ATTACHMENTS / PARTS (XT3 Enduro Series)

Date: **October 16, 2015**

Subject: **46" Blade Conversion Kit 759-05075**

FIGURE 1

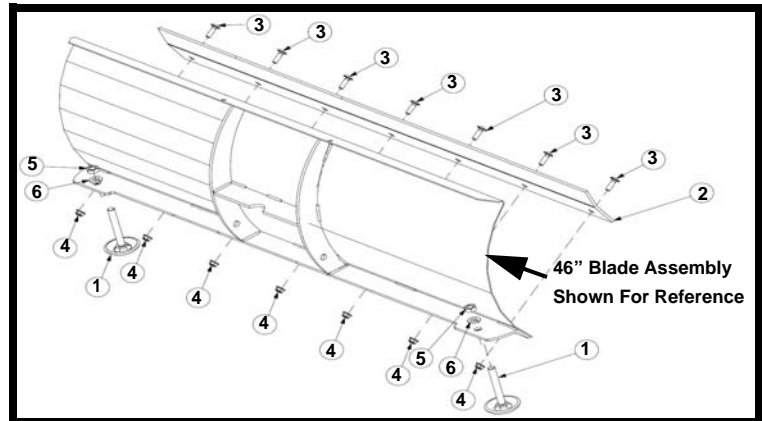
Changes were made to the Model Year 2015 60" Fabricated Deck (19A40025100). The 60" deck now comes with extended length front axles to be installed on the Model Year 2015 XT3 Enduro **GSX** Tractor (14AD3LE-010).

When a 60" fabricated mower deck has been installed along with the extended length axles, the 46" snow blade now requires the longer length skid shoes and Hi/Lo shave plate to achieve proper operation. Order one (1) **759-05075** GT 2000 46" Blade Conversion Kit when installing a **19A40022** (19A40022100) or **19B40022** (19B40022100) 46" Snow Blade onto a Model Year 2015 XT3 Enduro **GSX** (14AD3LE-010) with a 60" fabricated mower deck.

The Service Kit **759-05075** (Figure 1) has been created specifically for converting the **19A40022100** or **19B40022100** 46" Snow Blade to work with a Model Year 2015 XT3 Enduro **GSX** (14AD3LE-010) with a 60" fabricated mower deck.
